Interactive comment on “Developing an early warning system for storm surge inundation in the Philippines” by J. Tablazon et al.

J. Tablazon et al.

Received and published: 30 January 2015

Fig. 1. JMA Storm Surge Model Validation

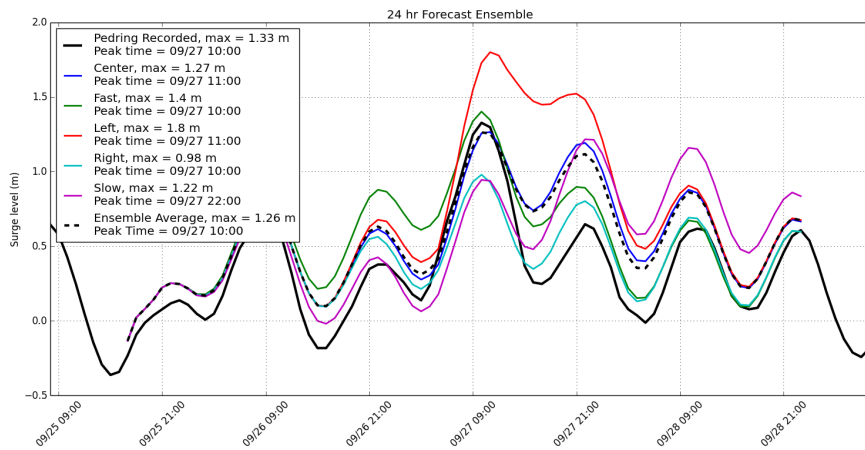
Referee Comment: are there events where you can compare your simulated results with actual inundation due to storm surge? If yes, it'll be beneficial to include

Authors' Response: Currently, we do not have validation for the simulated results with actual inundation. But, we do have validation for the results of the JMA Storm Surge Model.

Please see Fig. 1. This figure shows the forecast results of the JMA Storm Surge Model coupled with tide data from WXTide for Typhoon Pedring (Nesat) of 2011 for Manila Bay using ensemble forecasting. Basically, this figure only shows the difference between the model results using different tracks, considering possible track changes. The results of the model were compared to the actual sea level data from the National Mapping and Resource Information Authority of the Philippines. Evidently, the result of the ensemble average agrees well with the actual sea level data. We believe that the results of the JMA Storm Surge Model is sound and can be used for analysis.

Fig. 2. Tracks of tropical cyclones that generated the highest storm surge heights for Metro Manila

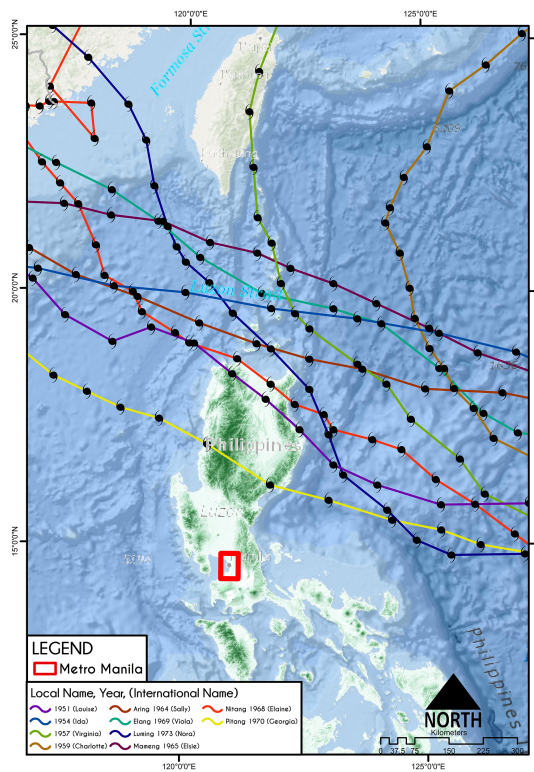
Referee Comment: from the enumerated factors that determine a storm surge, wind direction is vital, and in line with this, is it possible to show which storm path / track

produces significant storm surges in the area (is it to the north, south of the study area?)

Referee Comment: Figures - fig.2, are those simulated or from best track data?

Authors' Response: Please see Fig. 2. Here are the ten tropical cyclones that produced the highest storm surge heights for Metro Manila. As we can see, the tracks that generated the highest storm surge heights can be found north of the study area.

Authors' Response: These tracks are the ones simulated using the JMA Storm Surge Model and used for this study. These tracks are also from the best track data of the Japan Meteorological Agency.
